STAFF REPORT

CONCERNING APPLICATION FOR A CERTIFICATE OF APPROPRIATENESS

Application Number: 2018-0725

Property Location: 627 Portage Avenue

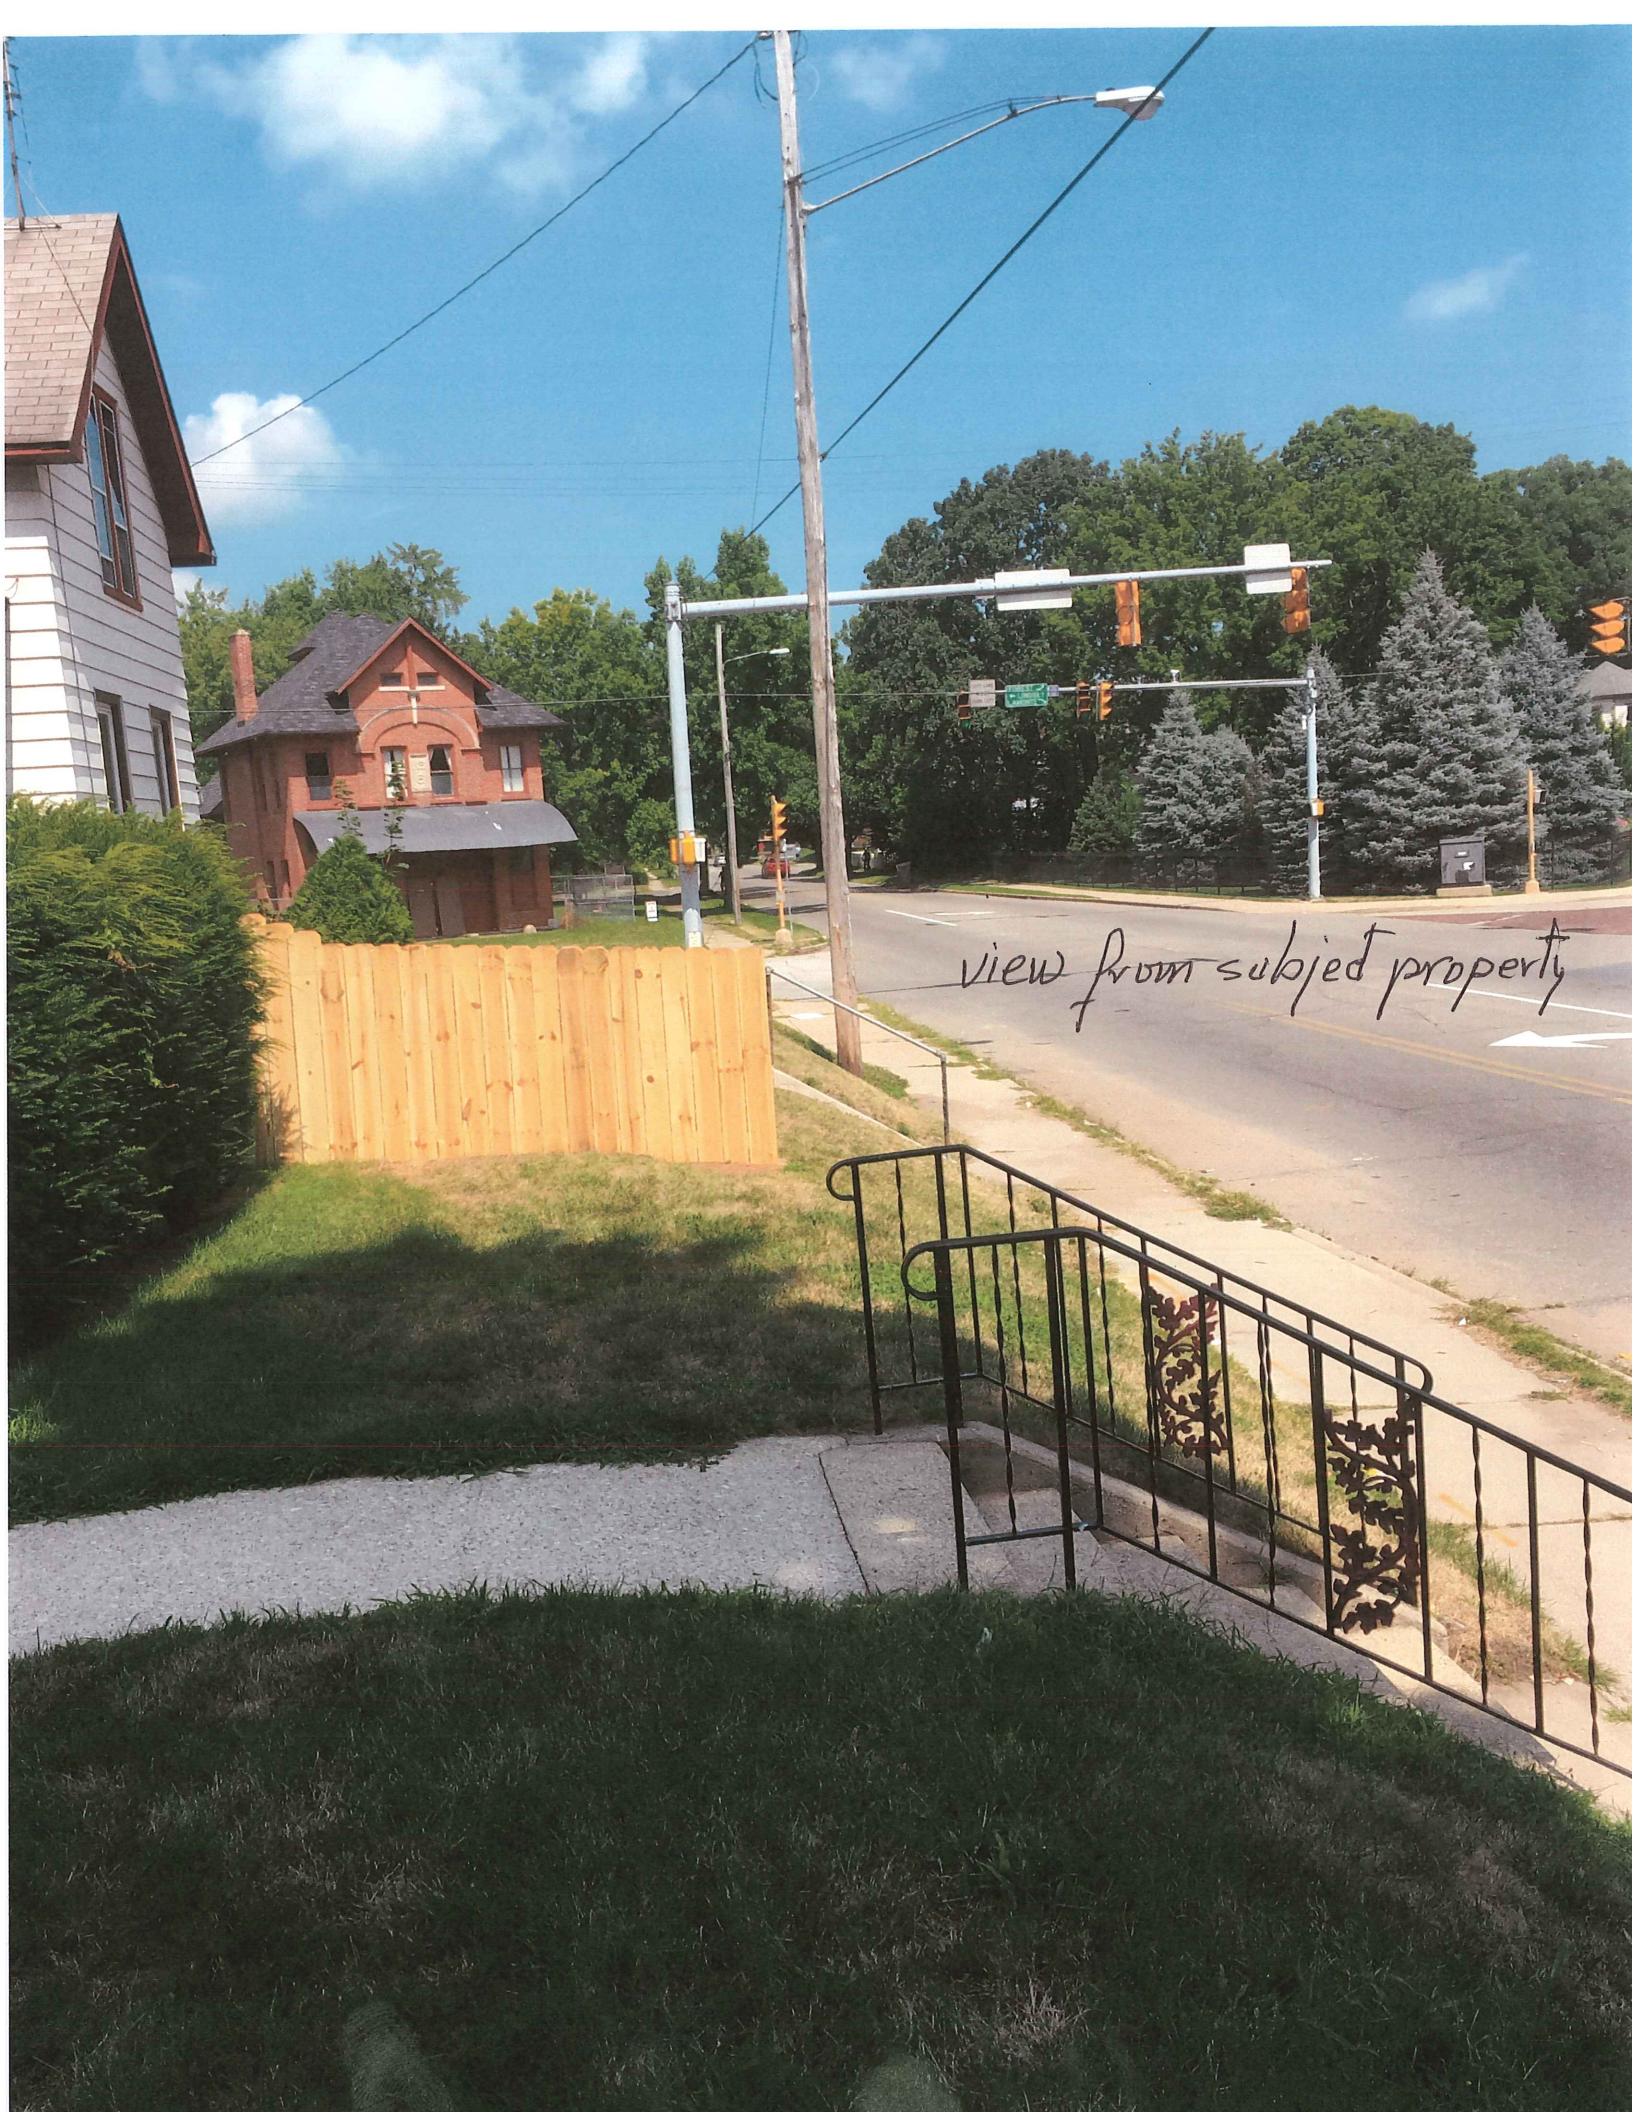
(1) Fence is 4" inside property line
